MINERALS PROGRAM INSPECTION REPORT PHONE: (303) 866-3567

MIINE NAME:		WIINE/PROSPECTING ID#:	WIINEKAL:	COUNTY:
East Wolf Creek Pit		M-2011-038	Stone	Mineral
INSPECTION TYPE:		INSPECTOR(S):	INSP. DATE:	INSP. TIME:
Monitoring		Travis H. Marshall	July 14, 2016	16:15
OPERATOR:		OPERATOR REPRESENTATIVE:	TYPE OF OPERATION:	
KW Enterprises LLC		Steven J. Winer	111 - Construction by Government Agency	
				-
REASON FOR INSPECTION:		BOND CALCULATION TYPE:	BOND AMOUNT:	
Normal I&E Program		Complete Bond	\$4,509.00	
DATE OF COMPLAINT:		POST INSP. CONTACTS:	JOINT INSP. AGENCY:	
NA		None	None	
WEATHER:	INSPECTOR'S SIGNATURE: SIGNATURE DATE:		`E:	
Clear	10 01		July 28, 2016	
		.0/nU1

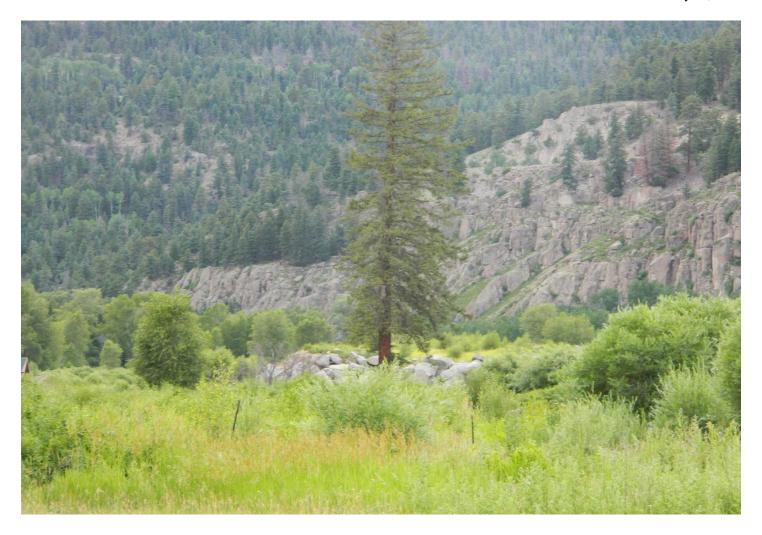
An abundance of Canada Thistle was observed on the site and the infestation is noted as a problem. Demonstrated control of the noxious weed infestation must be established in order for the site to be eligible for a future permit release if that is the operator's plan for the site. Please submit photo-documentation of exhibited weed control prior to August 19, 2016 to avoid enforcement action.

PROBLEM/POSSIBLE VIOLATION: Problem: There are state-listed noxious weeds present on site. This is a problem for failure to employ weed control methods for state listed noxious weed species within the permitted area, and to reduce the spread of weeds to nearby areas as required by Section 3.1.10 (6) of the rule. **CORRECTIVE ACTIONS:** Implement approved weed control plan and provide proof to the Division that this has been done. If a weed control plan is not already in place, the operator shall develop a weed control and management plan in accordance with Section 3.1.10 (6) of the Rule. This plan should be developed in consultation with the county extension agency, or weed control district office and should include specific control measures to be applied, a schedule for when control measures will be applied and a post-treatment monitoring plan. This weed control plan shall be submitted to the Division as a Technical Revision to the approved plan with the appropriate Technical Revision fee of \$216.00 by the corrective action date.
